Blue Parkway Mixed Use Residential

Residential Rezoning with Preliminary Development Plan

#PL2021-282

9-23-2021

Density, Lot Width and Minimum Lot Size (RP-1 zoning district).

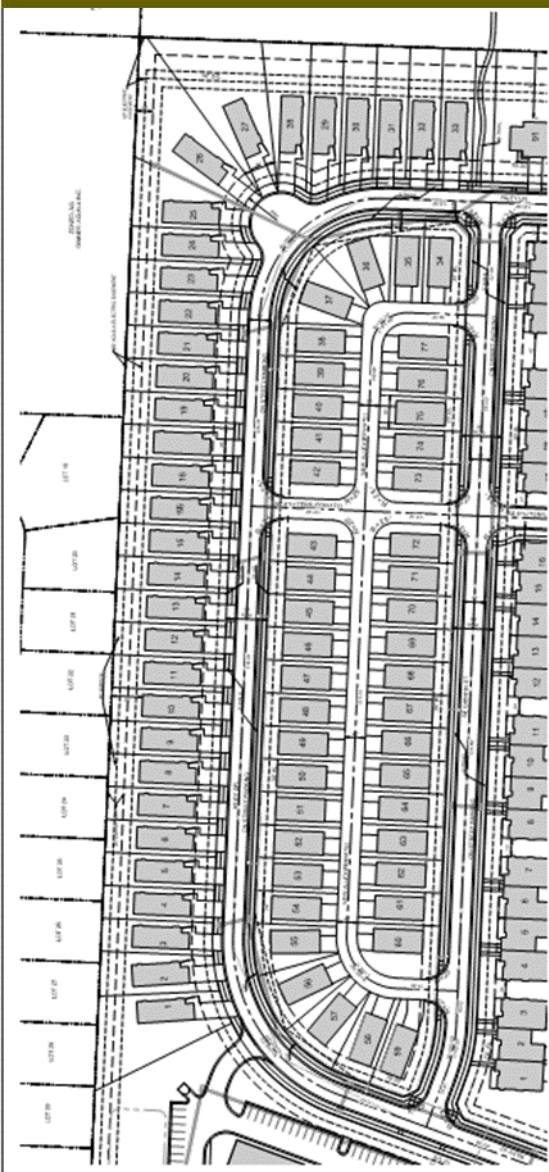
- Required – 4 dwelling units per acre maximum in the RP-1 district; minimum lot width of 60' for single-family homes; and minimum 6,600 sq. ft. lot size per dwelling unit
- Proposed – 6.18 dwelling units per acre; 40' lot width for single-family lots; and 4,000 sq. ft. per lot.

1. A modification of UDO Sec. 6.030, Table 6-2, Density, shall be granted to allow 6.18 units per acre for the RP-1 district instead of 4 units per acre.

2. A modification of UDO Sec. 6.030, Table 6-2, Minimum Lot Width, shall be granted to allow minimum lot widths of 40' for the RP-1 district instead of 60'.

3. A modification of UDO Sec. 6.030, Table 6-2, Minimum Lot Size, shall be granted to allow a minimum of 4,000 sf. per lot for the RP-1 district instead of 6,600 sf. per lot.

Density and Minimum Lot Size (RP-4 zoning district). Modifications requested

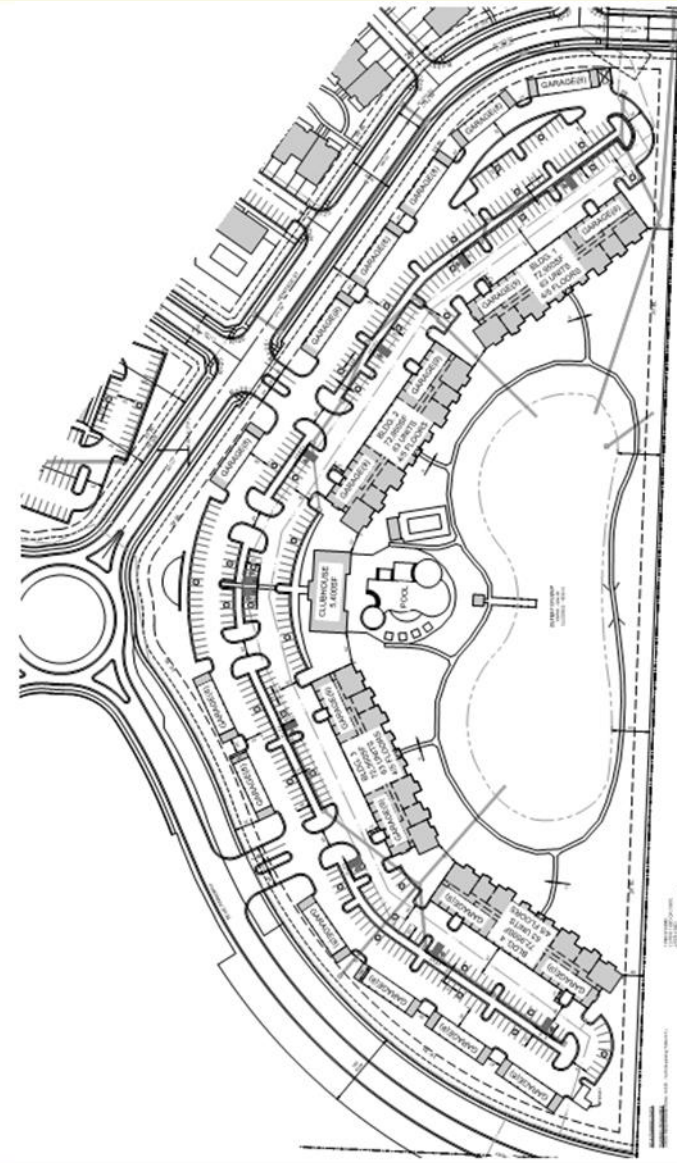
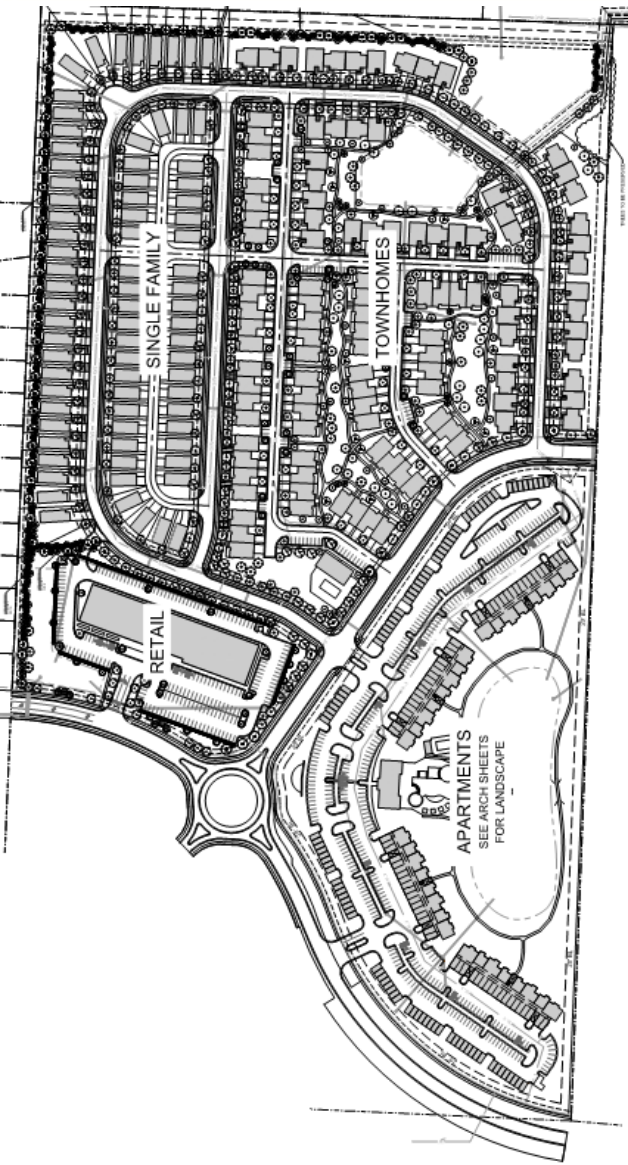
- Required – 12 dwelling units per acre maximum in the RP-4 district; and minimum 3,500 sq. ft. lot size per dwelling unit
- Proposed – 13.12 dwelling units per acre; and 3,300 sq. ft. lot size per dwelling unit

4. A modification of UDO Sec. 6.030, Table 6-2, Density, shall be granted to allow 13.12 units per acre for the RP-4 district instead of 12 units to the acre.

5. A modification of UDO Sec. 6.030, Table 6-2, Minimum Lot Size, shall be granted to allow a minimum lot size of 3,300 sf. per unit for the RP-4 district instead of 3,500 sf. per unit.

Landscaping, Caliper Size and Height. Modification requested. Staff supports the requested modifications.

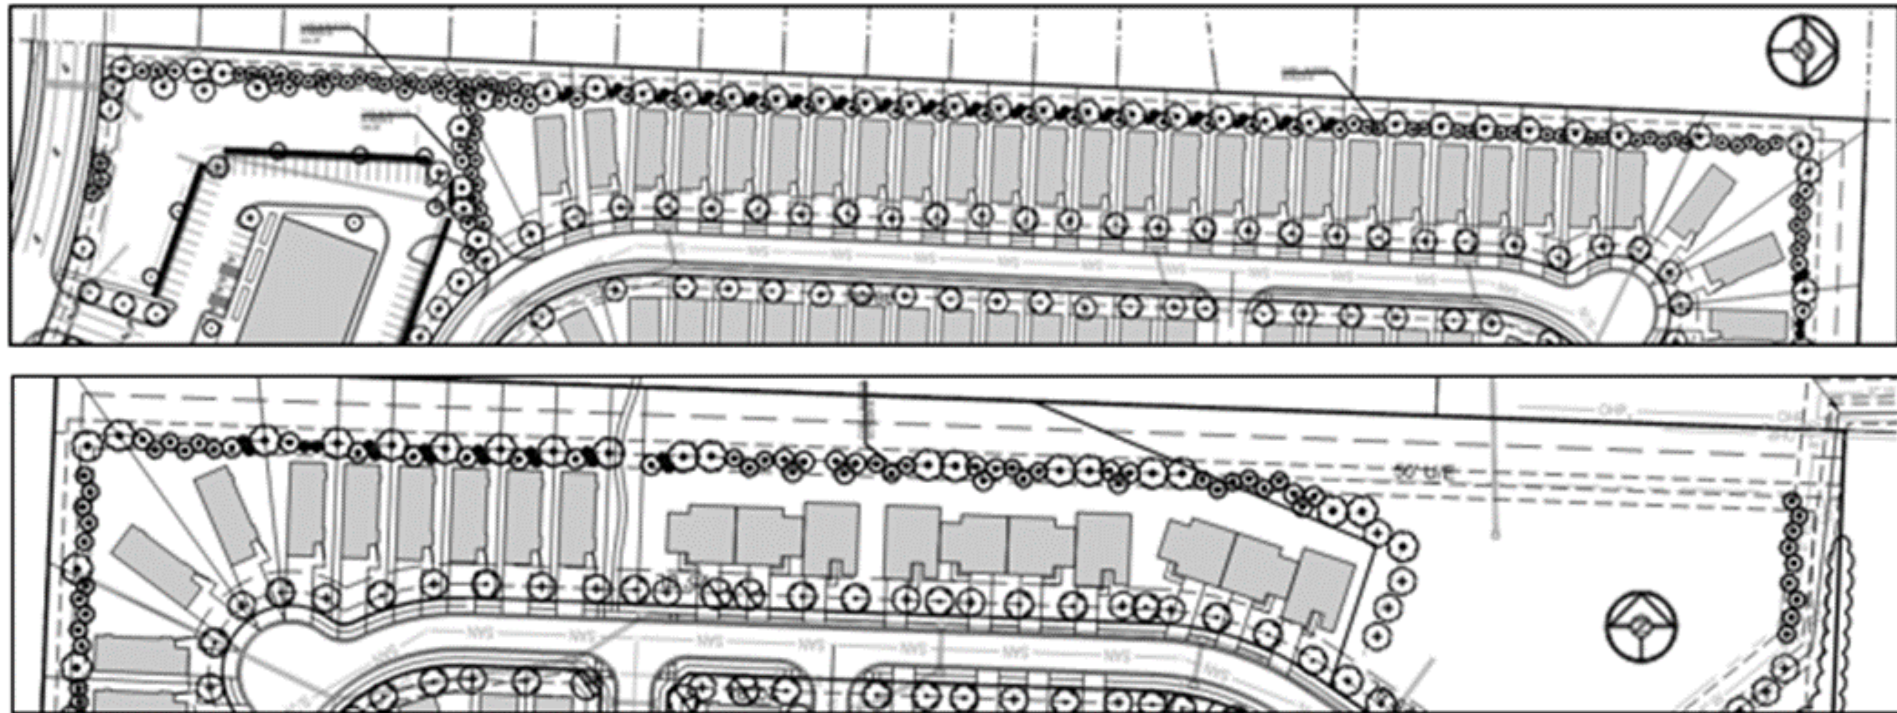
- Required – Section 8.750 of the UDO requires a minimum of 3-inch caliper, measured at a point 6 inches above the ground or top of the root ball for deciduous trees, at planting; and Section 8.750 of the UDO requires a minimum height of 8 feet at planting for evergreen trees.
- Proposed – The applicant has requested two modifications to this requirement: (1) a minimum 2.5-inch caliper for shade trees; (2) a minimum 2-inch caliper for ornamental trees; and (3) a minimum height of 6' for evergreen trees.

6. A modification of UDO Sec. 8.750 shall be granted to allow a minimum 2.5-inch caliper for shade trees instead of 3-inch.
7. A modification of UDO Sec. 8.750 shall be granted to allow a minimum 2.0-inch caliper for ornamental trees instead of 3-inch.

8. A modification of UDO Sec. 8.750 shall be granted to allow a minimum 6' tall for evergreen trees instead of 8' tall.
9. A modification of UDO Sec. 8.750 shall be granted to allow the required 20'-wide high-impact landscape buffers to be located off the property line in accordance with the submitted landscape plans dated September 2, 2021.

High-impact Landscape Buffer Location. Modification requested.

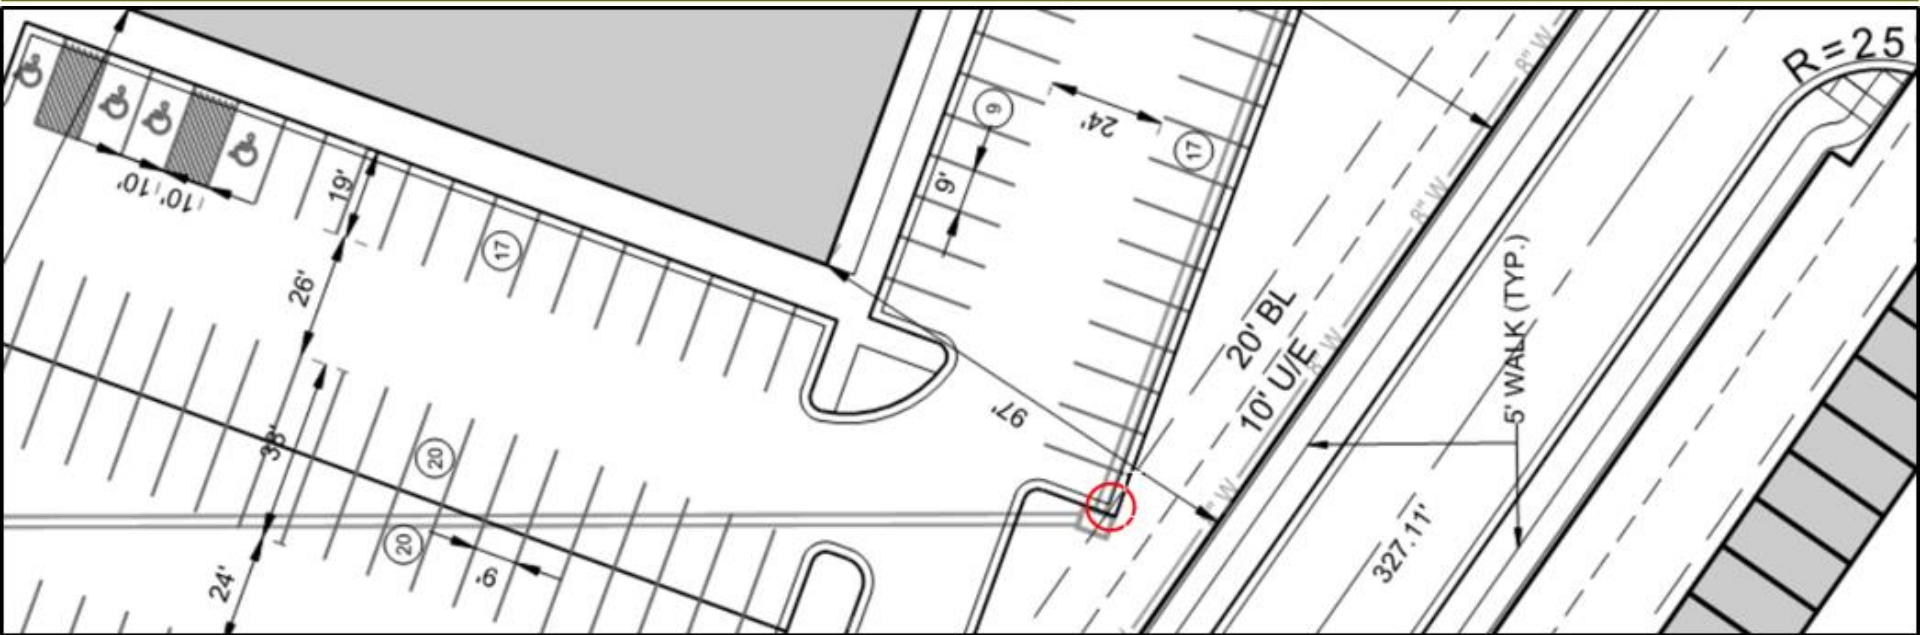
- Required – The required 20'-wide high-impact landscape buffer shall be located abutting the property line.
- Proposed – The required 20'-wide high-impact buffer will be set back from the property line.

Parking lot setback. Modification requested. Staff supports the requested modification.

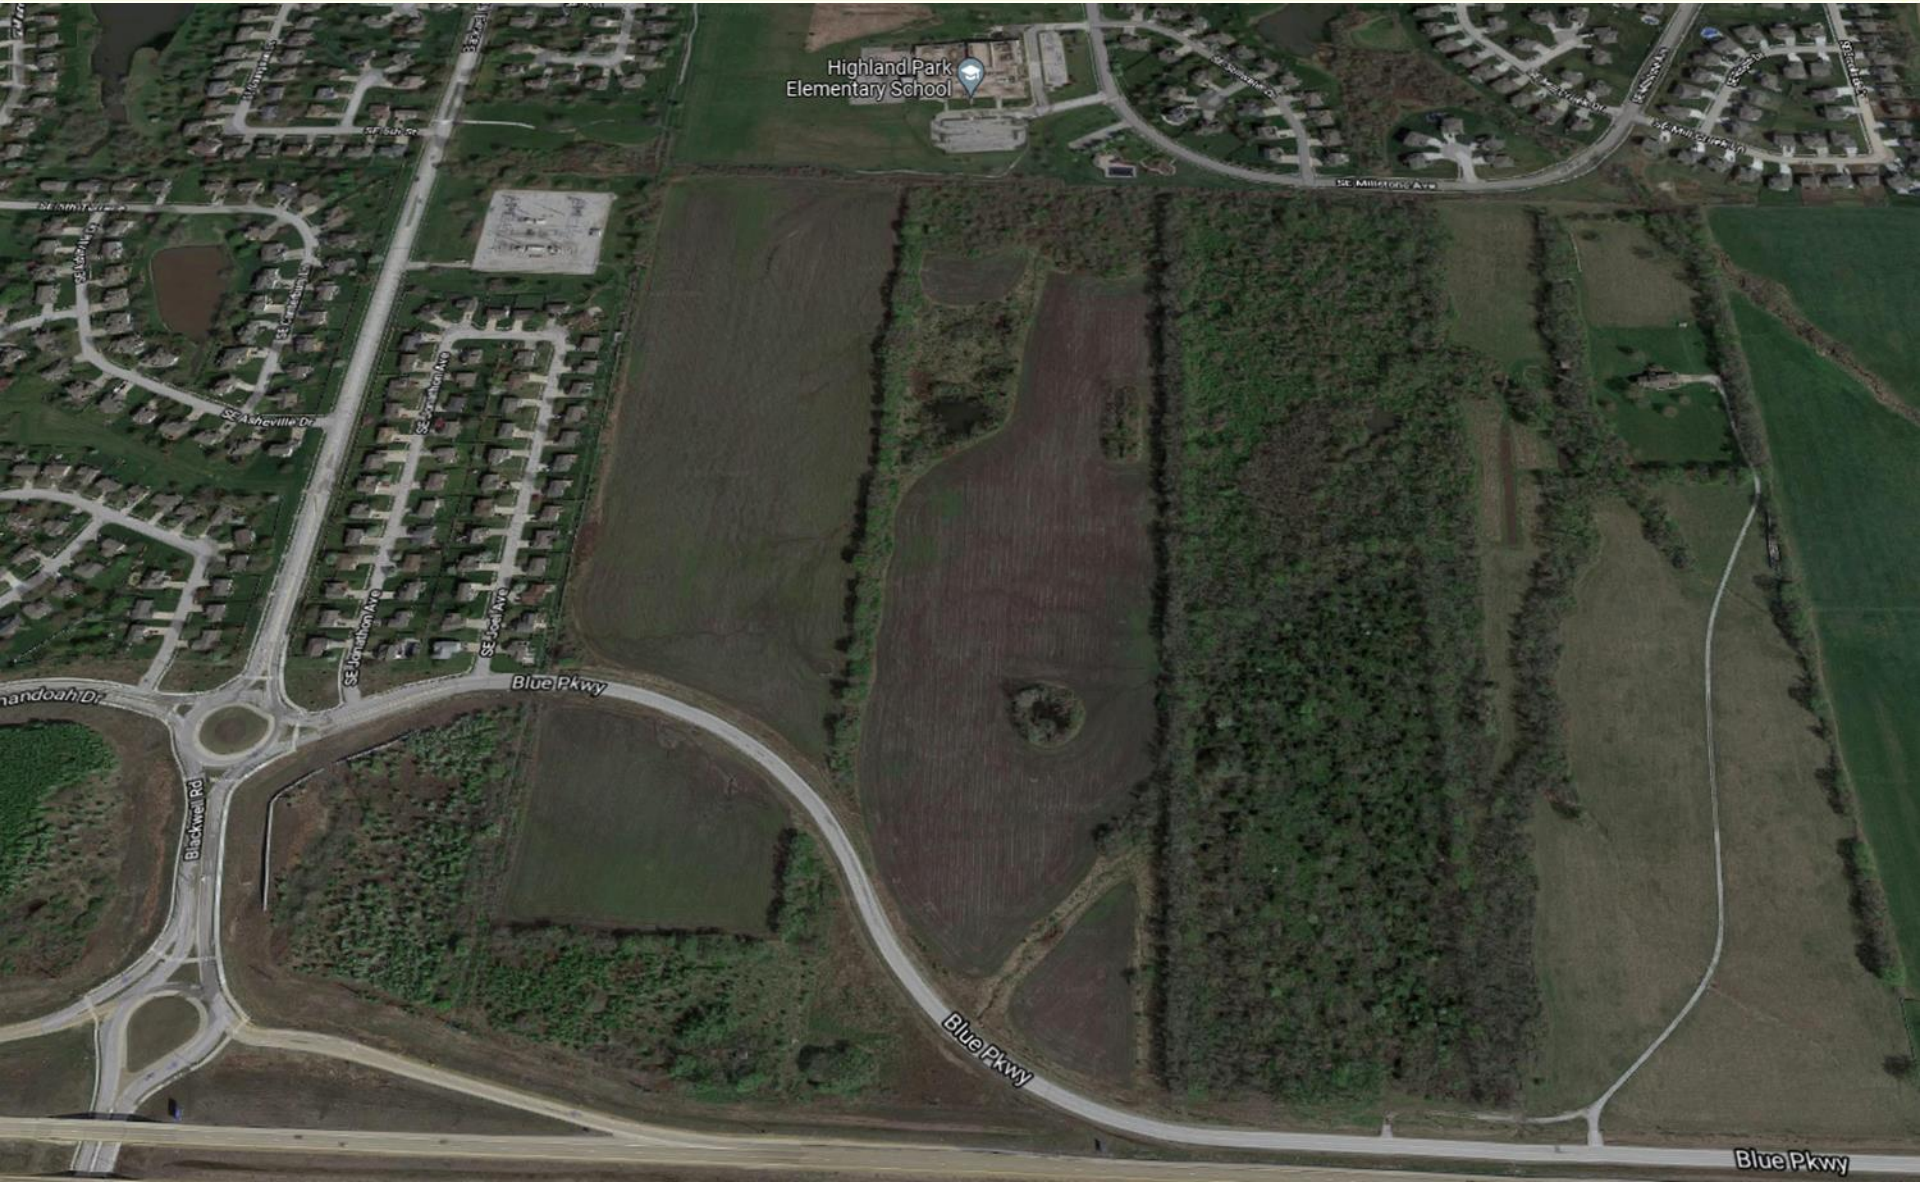
- Required - The UDO requires parking lots to be set back a minimum 20' from any public right-of-way.
- Proposed - The applicant proposes to reduce the required parking lot setback from 20' to 18' along the east property line adjacent to SE Heritage Street.

10. A modification shall be granted to reduce the required parking lot setback from 20' to 18' along the east property line adjacent to SE Heritage Street.
